Subject: FW: DC/25/99887 32A QUEENS VIEW, NETLEY ABBEY - Discharge of Conditions - landscape comments

Planting Plan Rev E

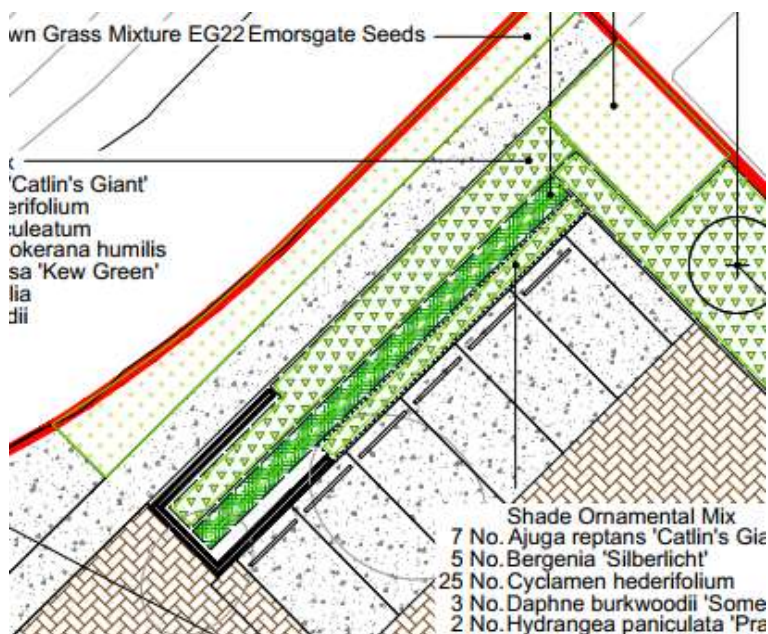
a/ Tree planting - successful delivery of the tree planting is critical to the landscape setting for this project. Whilst the general arrangement of trees is acceptable, I am not clear why some trees have not been planted in the location below to soften the frontage to Queens View?

There appears to be an opportunity to plant a line of 3 trees here.

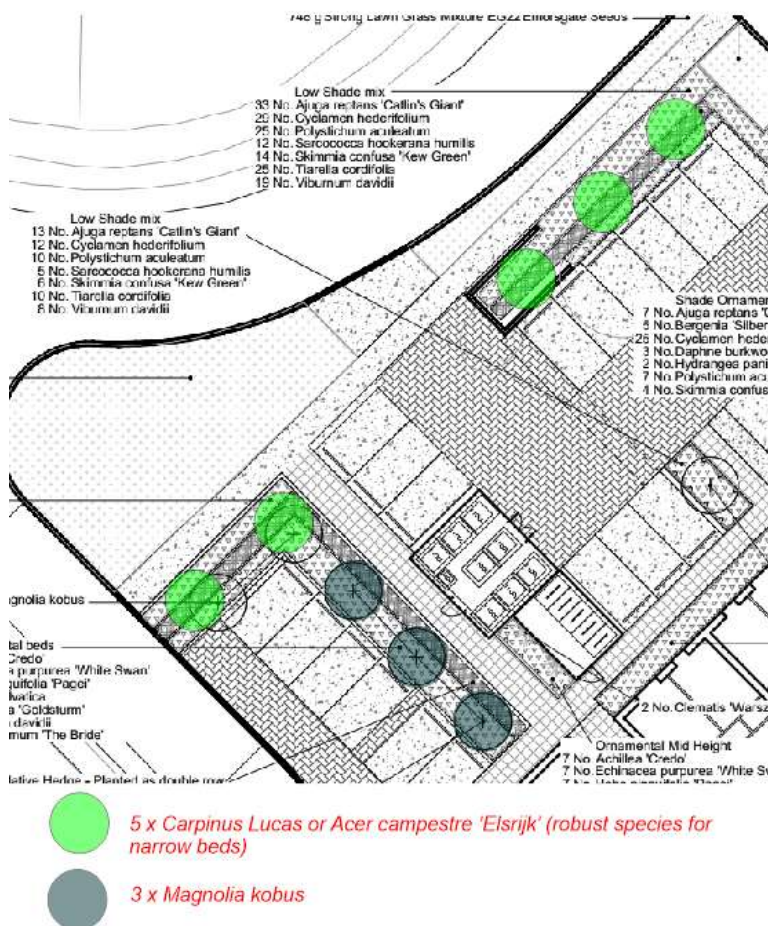
Please omit the Amelanchier tree here as it is too tight to the building and will crowd the adjacent Prunus spp. tree.
